**SAM G55 Series Family  
Silicon Errata and Data Sheet Clarification**

The SAM G55 Series family of devices that you have received conform functionally to the current Device Data Sheet (Atmel-11289F-ATARM-SAM-G55G-SAM-G55J-Datasheet\_27-May-16), except for the anomalies described in this document.

The following typographic corrections and clarifications are to be noted for the latest revision of the device data sheet (Atmel-11289F-ATARM-SAM-G55G-SAM-G55J-Datasheet\_27-May-16).

## 8. Module: USART - Transmitter Operations

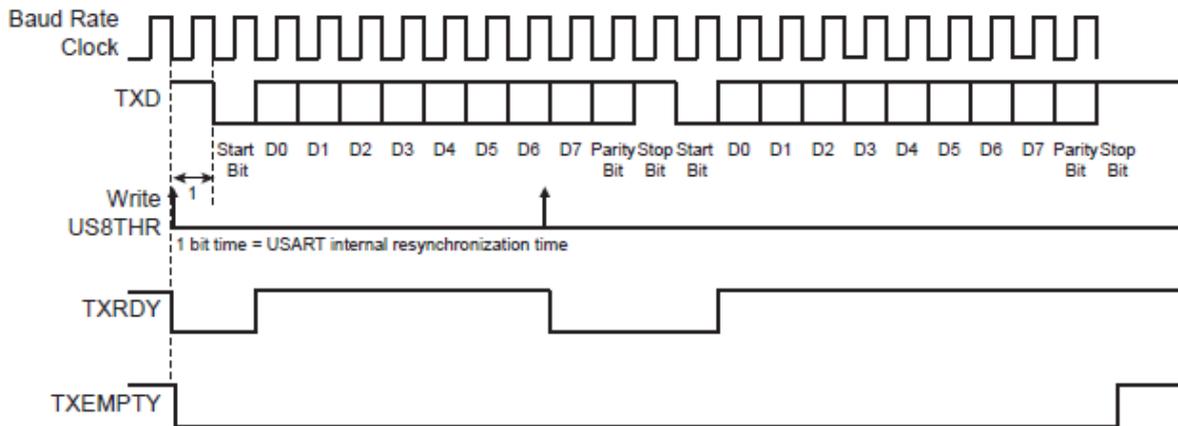
Figure 30-6 is incorrect. The corrected figure is as shown below:
